Access Compliance Report

Public Rights-of-Way

(Curb Ramps)

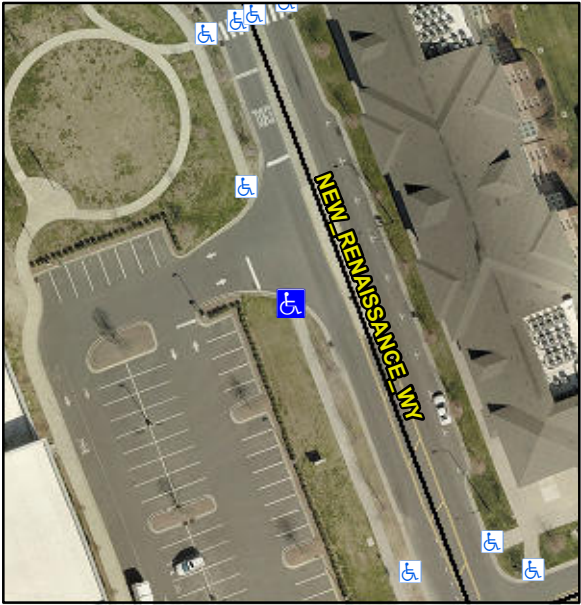
Intersection ID: 10032958		Main Street: NEW RENAISSANCE_WY	Cross Street: N/A	Location:	SW
ADA ID: A6F7B3A04F78		Ramp Type: Directional1	Initial Pass/Fail: Fail	Overall Compliance: No	Severity Score: 1.25
Codes/Mitigation Info/Possible Solution			Field Measurements/Component Compliance		
	Possible Solutions:		Compliance	Description	Data
	Remove & Replace Entire Ramp.		N/A	Ramp Length (in)	52.0
			Yes	Ramp Width (in)	72.0
			Yes	Ramp Slope (%)	1.9
			No	Ramp XSlope (%)	3.6
			N/A	Flare Type LT	N/A
			N/A	Flare Slope LT (%)	N/A
			N/A	Flare Traversable LT?	N/A
			N/A	Landing Length (in)	0.0
			N/A	Landing Width (in)	0.0
Surveyor Notes:		Compliance	Description	Data	
N/A		N/A	Flare Slope RT (%)	N/A	0.0
		N/A	Flare Traversable RT?	N/A	N/A
		N/A	DWS Provided?	N/A	N/A
		N/A	DWS Contrast?	N/A	N/A
		N/A	DWS Length (in)	N/A	N/A
		N/A	DWS Full Width?	N/A	N/A
		N/A	DWS Offset LT (in)	N/A	N/A
		N/A	DWS Offset RT (in)	N/A	N/A

N/A	Gutter Slope (%)	N/A	N/A
		N/A	Gutter X Slope (%)	N/A	N/A
		N/A	Road Slope (%)	2.6	
		N/A	Road X Slope (%)	2.4	
		N/A	Clear Space?	N/A	
		N/A	Clear Space to XWalk (in)	N/A	
		N/A	Storm Grate/Utility Hazard?	N/A	
		N/A	Storm Grate/Utility Type		
		N/A	Surface Condition? (G/P)	Good	
		N/A	Curb Slope (%)	5.4	
PROW/ADA:					
R304.5.3					
Total Cost:		\$	1600.00		
Street 1 Name	ENTRANCE				
Stop Condition-Street 1	StopSign				
Street 2 Name	N/A				
Stop Condition-Street 2	N/A
